Change Notice for Modifying Approved Documents/ Workplans
In Accordance with the Tri-Party Agreement Action Plan,
Section 9.0, *Documentation and Records*

Change Number	Document Submitted Under Tri-Party Agreement Milestone	Date:
TPA-CN-219	N/A	05/06/08
Document Number and Title: SGW-36088, Revision 0, Waste Control Plan for the 200-SC-1 Operable Unit, and DOE/RL-2007-0-VOL II, Rev. 0, Supplemental Remedial Investigation/Feasibility Study Work Plan for the 200 Area Central Plateau Operable Units, Volume II: Site-Specific Field-Sampling Plan Addenda.		Date Document Last Issued: January 2008 and December 2007
Originator: J. S. Decker		Phone: 376-4416 or 528-0808
Description of Change: Add one boring at 216-B-55 crib, one boring at 216-T-36 crib and change the analyte list for 216-A-30 crib.		
<p><u>B. L. Charboneau</u> and <u>C. Cameron</u> agree that the proposed change modifies an approved RL Lead Regulatory Agency</p> <p>workplan/document and will be processed in accordance with the Tri-Party Agreement Action Plan, Section 9.0, <i>Documentation and Records</i>, and not Chapter 12.0, <i>Changes to the Agreement</i>.</p> <p>Table 3, 200-SC-1 Planned Well List, of SGW-36088, Revisio

Figure -- 1

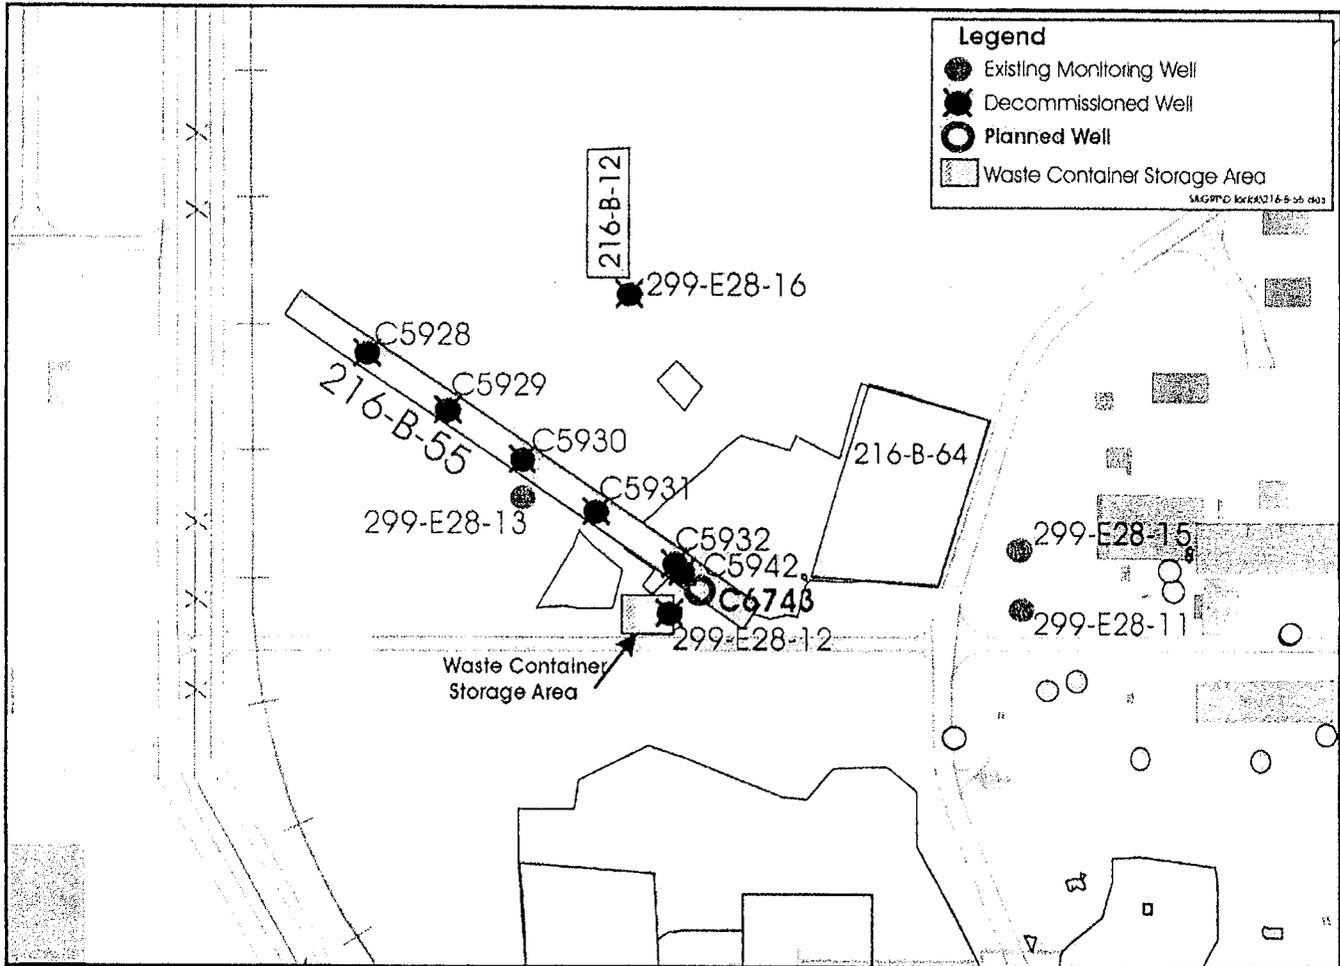
<p>Justification and Impacts of Change:</p> <p>New information suggests that the degree of radiological contamination in 216-T-36 maybe greater than estimated in historical documents. The additional direct push technology borehole at 216-T-36 will verify radiological contamination levels using geophysical logging for health and safety planning purposes. This borehole will be drilled if it is determined that supplemental characterization of 216-T-36 is necessary through the process described in the work plan and sampling and analysis plan for 216-T-36 (DOE/RL-2007-02-VOL II, Rev. 0).</p> <p>The changes pertaining to 216-B-55 and 216-A-30 implement a characterization recovery plan for the two waste sites. The characterization recovery plan addresses missed sample hold times for some of the samples collected during characterization performed at the two waste sites.</p> <p>The plan for 216-B-55 is to drill and sample another borehole, C6743, near the inlet of the crib at the expected edge of the crib. The location is perpendicular to the crib centerline by a distance of approximately 11 feet. The additional samples from this location are intended to provide information on the nature and extent of contamination as described in the Rationale for Proposed Supplemental Data Collection Activities (DOE/RL-2007-02-VOL I, Rev. 0, Table C-2). The data from the original characterization borehole and the additional data from the additional borehole will satisfy the requirements of the applicable work plan, and if it is determined that any additional characterization is required, any additional characterization would be pursued through the follow-on DQO process described in the work plan (DOE/RL-2007-02-VOL I, Rev. 0, A2.4.4 Follow-On Data Quality Objectives).</p> <p>The plan for 216-A-30 is to evaluate the data collected during characterization and determine whether additional characterization is required through the follow-on DQO process described (DOE/RL-2007-02-VOL I, Rev. 0, A2.4.4 Follow-On Data Quality Objectives). In order to satisfy the data collection requirements of the work plan and sampling and analysis plan, the sulfide and organic compounds were deleted from the analyte list for 216-A-30.</p>
